5.0 Amended Design

Revisions to original submission

5.3 Final Proposals

Revisions between P1 and P2 Proposals

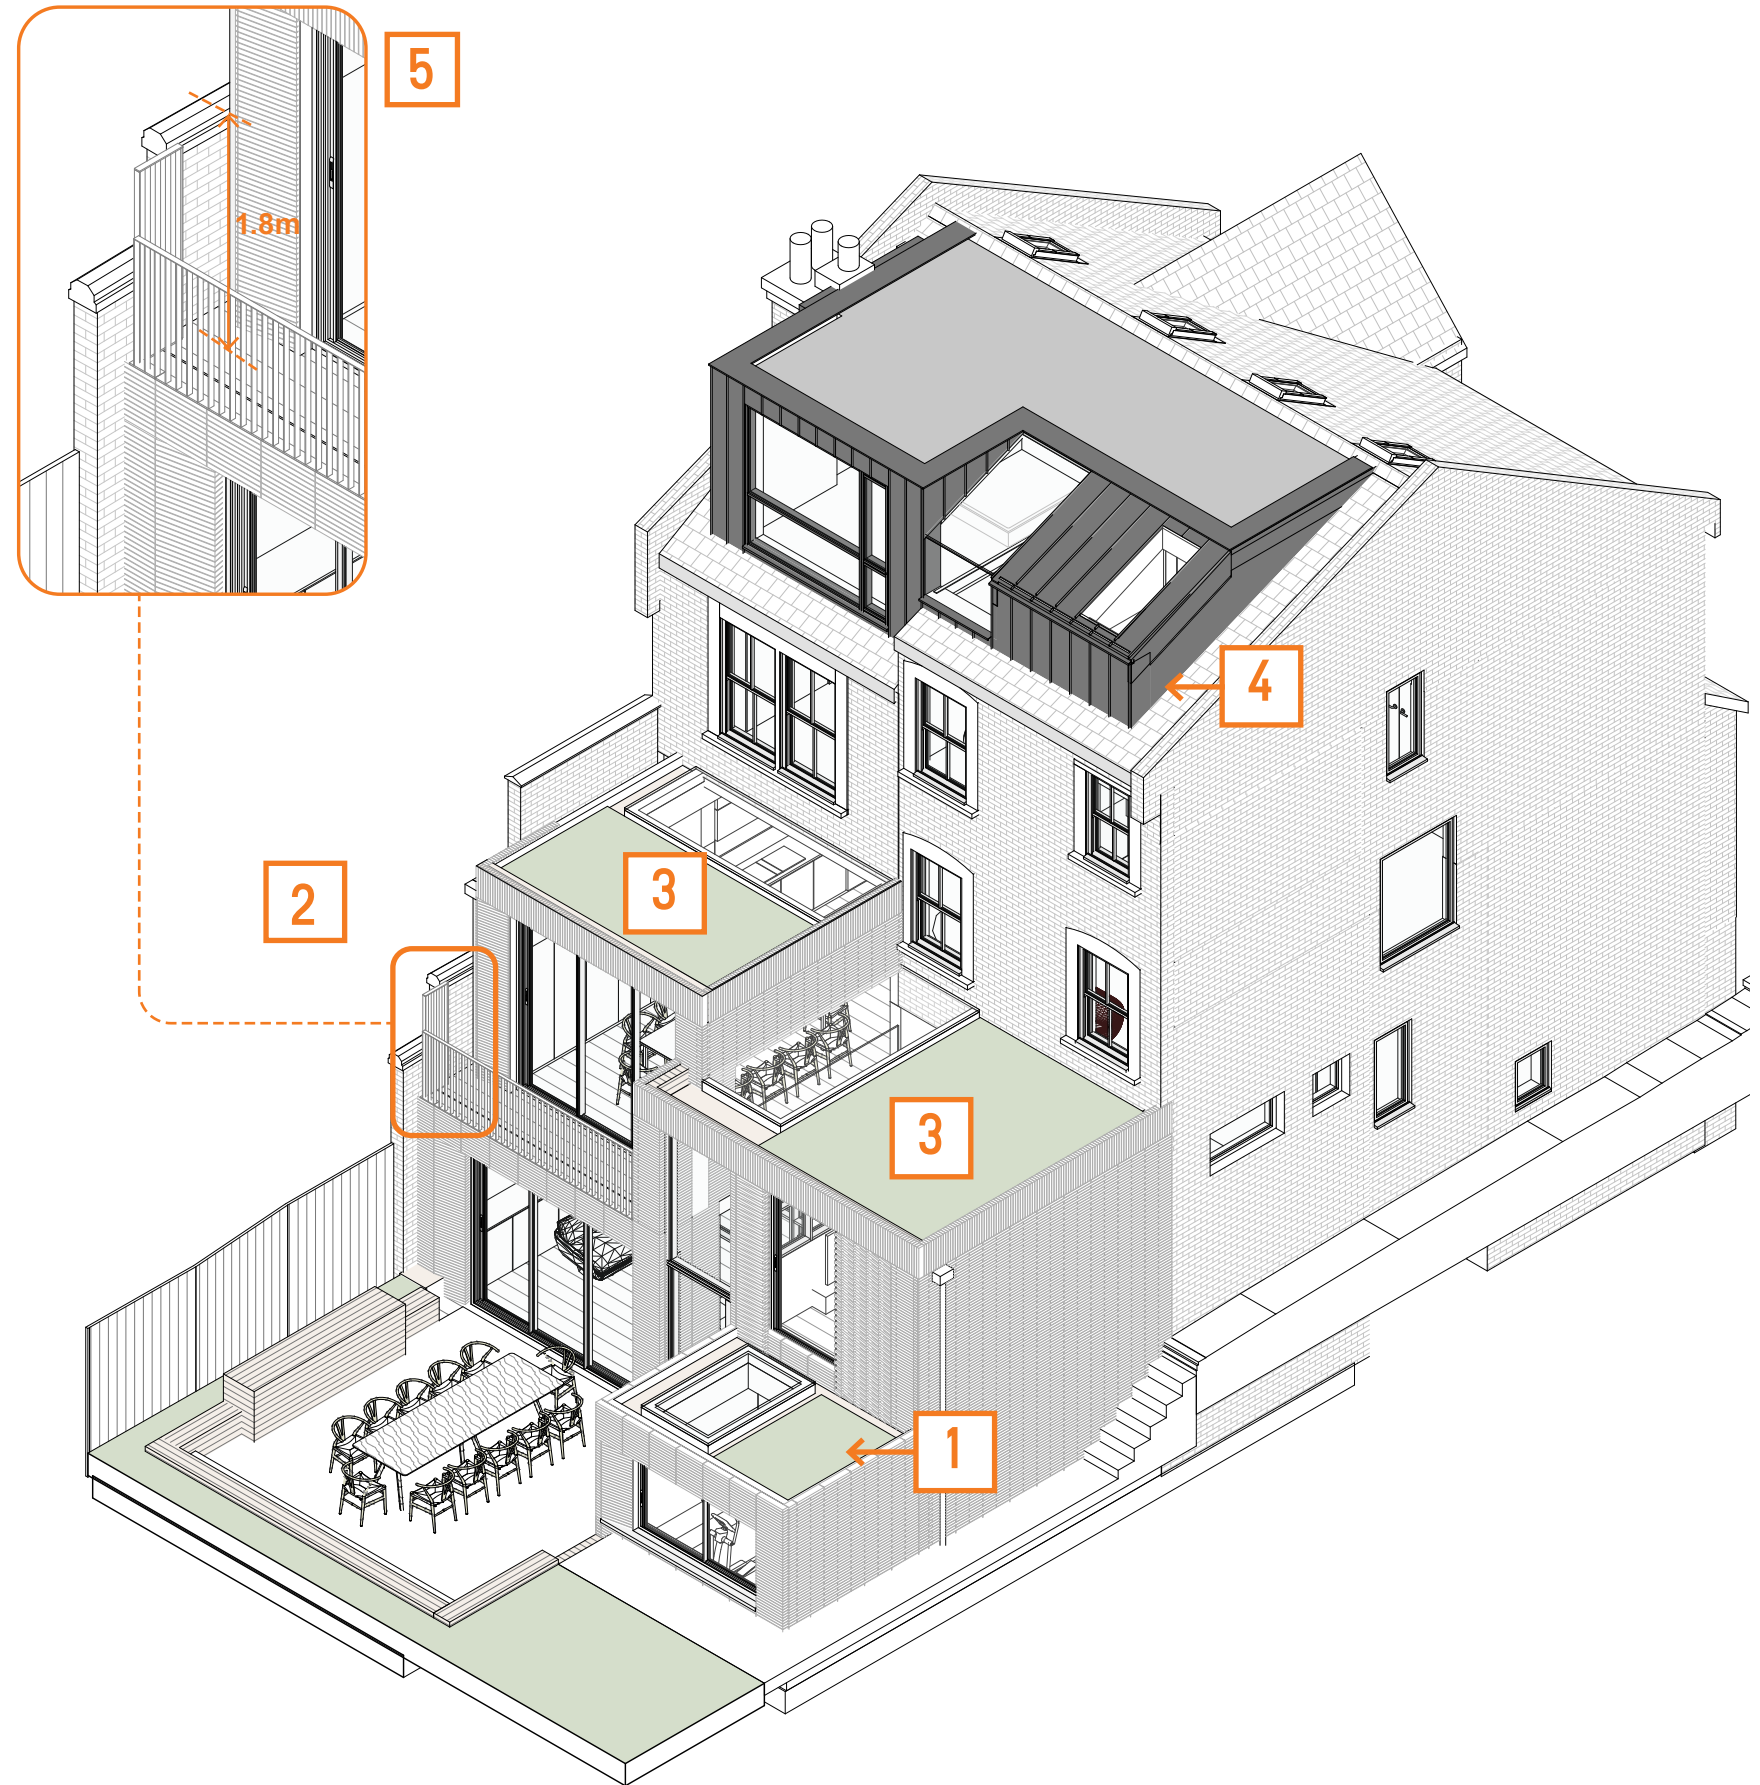
We have now revised the proposals and updated all relevant drawings in response to correspondence with our Case Officer. For clarity, we have listed out the changes here between the P1 and P2 revisions.

1. Terrace Replaced with Green Roof

The lower ground floor terrace serving the snug has been replaced with a green roof and rooflight, and the balustrade has been removed. Access to this roof will be for maintenance only. The terrace, and therefore overlooking issues raised have been omitted.

2. Revised Massing

In response to discussions with the Case Officer, the upper-level massing has been set back so that the external face of the new façade aligns with the external face of the existing balustrade. This adjustment creates a small terrace adjacent to the kitchen, which is screened along the boundary line with a minimal privacy screen (see point 5)

3. New Green Roofs

We also consider that adding green roofs to the two main extensions will strengthen the proposal, as this will improve biodiversity, as well as being more pleasant for the resident and neighbours to look out over. These have been added to the flat rooves throughout.

4. Dormer Extension Inset

We have tested setting the dormer extension further in on the side of No. 107 to better align with the neighbouring approved scheme. The ensuite external wall is now set 800mm in from the parapet gable. This is equivalent to the set back on the 107. The dormer extension has been set in on the front edge also compared with the P1 Revision scheme.

5. Screening at Boundary

The revised proposal replicates the existing terrace arrangement, allowing for a small terrace area adjacent to the kitchen/dining room. Along this edge, the existing 1.8m-high brick parapet wall is retained, providing effective screening to the neighbouring property at No. 111. In addition, a small section of angled railing has been introduced above the lower boundary wall to prevent overlooking while still permitting light and airflow through the opening. The railing aligns with the height of the existing parapet.
